Technical Information Bulletin

Mar. 5, 1999 **# TIB0002**

Purpose:

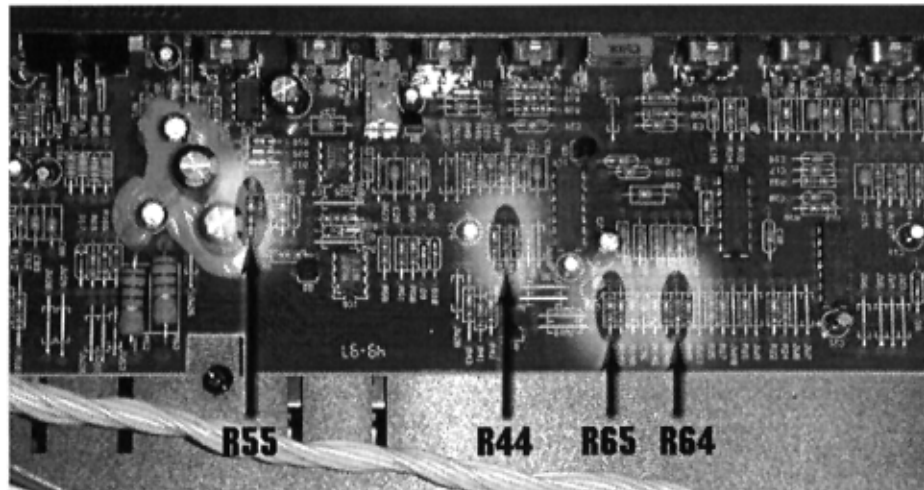
4. Position the amp with its front panel away from you and gently pull the chassis assembly out from the cabinet. Take care not to damage the speaker wires! Rest the chassis assembly on your work surface, behind the cabinet (see photo below).
